**TENTH AVENUE PORT ACCESS PROJECT  
NOTES FROM COMMUNITY MEETING**

**Meeting Date: Thursday, October 4, 2012**

AGENCY	Rita De La Fuente	Port of SD
ATTENDANCE:	Jerine Rosato	Port of SD
	Grace Tell	Port of SD
	Lara Gates	City of San Diego
	Marta	City of San Diego (District 8 rep)
	Jacqueline Appleton-Deane	Caltrans
	Oscar Cortes	Caltrans
	Mario Orso	Caltrans
	Andrea Hoff	SANDAG
	Louise Torio	SANDAG
	Vicki Estrada	Estrada Land Planning
	Artemisa Zuaza	Graphic Solutions
	Kirk Bradbury	QIC
COMMUNITY ATTENDANCE:	Approximately 50 Members of the Public	
LOCATION:	Woodbury School of Architecture 2212 Main St. San Diego, CA 92113	TIME: 5:30 p.m. to 7:00 p.m.
SUBJECT:	<b>Barrio Logan Community Gateway Sign 2<sup>nd</sup> Meeting with Community</b>

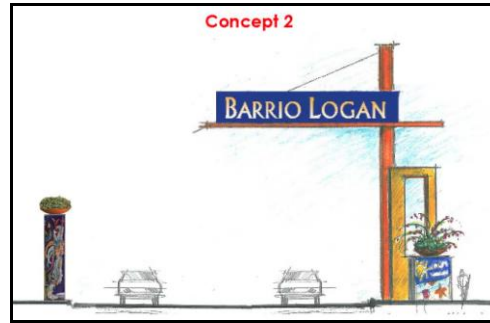
- I like the arch sign (Concept 1). It's more iconic and simpler.
  - Is more typical
  - Like the truss
    - Victorian/Mission style
    - But maybe too industrial

- I like arch but missing indigenous elements - Aztec.
- Consider the tail and head of lion/serpent along arch like previous sketch.
- I like the blue background on arch. Comment from Artemisa Zuaza, Graphic Solutions: the color is traditional, rich, deep.

- I like arch but may be too colonial or hacienda style.
- The steel arch does not represent the community, should be:
  - Masonry arch
  - Paint, changing murals

- Iron work center of Concept 1 is not indigenous
  - More Aztec shapes/flowers
- Could the sign be left unfinished? Answer by Mario Orso, Caltrans: the sign's objective is to deter trucks leaving the Port Marine Terminal from traversing the neighborhood by using a context sensitive solution, in this case an overhead Gateway sign. The project has tight schedule deadlines related to funding. One idea is to construct the main structure of the sign if consensus on all details cannot be reached and the community wants to proceed in determining details at some time in the near future so that funding is not jeopardized. Estrada, as the sign designer, could leave portions of the design unfinished as a 'canvas' to be completed later.

- The arch is too simple.
  - The Circle in middle gets lost
- The medallion is not good.
  - Not unique
- Details can come later.
  - Second phase
- I like the arch.

- Embodies the community like Chicano Park has done
  - Don't like medallion
- Artenisia Zuaza, Graphic Solutions: These are preliminary concepts. Wanted to identify shape.

- How wide is the sign span? Answer: about 40'-50', and needs to be designed to carry a high wind load
- The columns are good for expression.
- Consider placing the letters on top arch and use arch area for expression.

- Consider placing the blue background all the way across. Community feedback: Blue all the way across will raise the sign's exposure to the wind making the sign more expensive and bulkier than otherwise.

- Columns could be similar to Little Italy sign and represent the community and tell a story: Fishing on west, families on east.
- I like perforated metal but am concerned with light maintenance
- I think it's best to build the structure now and figure out final details later
  - Leave tile, metal, or other blank canvas
- The columns material could be concrete block or steel.

Now we know two columns and arch we can refine the concept. The letters would glow from the back.

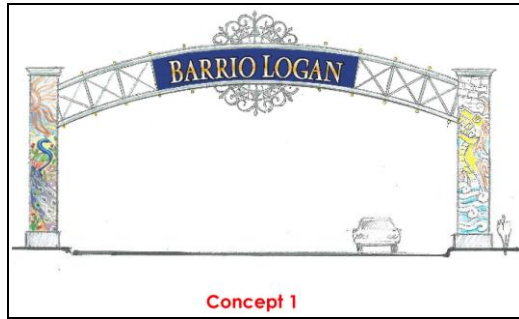
- I want the sign to go across the entire street.
- Would both sign concepts be illuminated? Answer: Yes.
- What type of material is Concept 2 made of? Answer: Could be various materials, concrete or metal.

Observation by Vicki: "Nobody likes the 'modern sign' (Concept 2)" – No disagreement from attendees.
